ASB-1009

Service Bulletin

Subject: TS-950SDX 3rd Order IMD Standardization **Date:** January 25, 1993

Final Unit (X45-3450-00) Component Side View

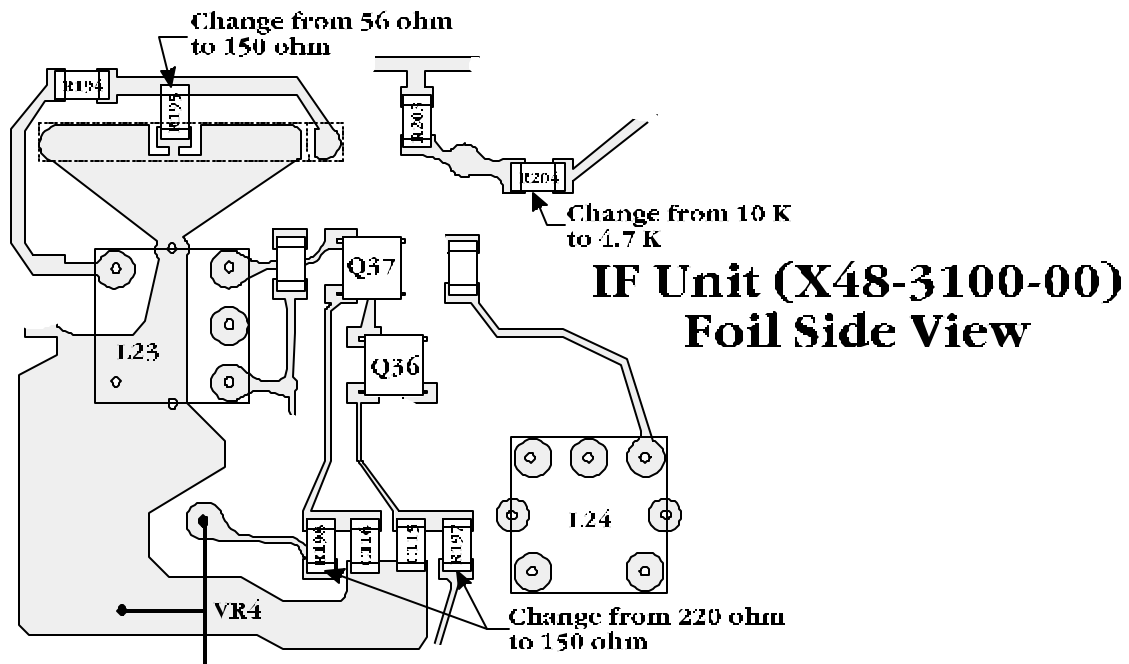
1. On the Final Unit (X45-3450-00) change R19 and R20 from 10 ohms to 22 ohms. (Fig. 1)
2. On the IF Unit (X48-3100-00): (Fig. 2)
 - a. Change R195 from 56 ohms to 150 ohms
 - b. Change R197 from 220 ohms to 150 ohms
 - c. Change R198 from 220 ohms to 150 ohms
 - d. Change R204 from 10K ohms to 4.7K ohms
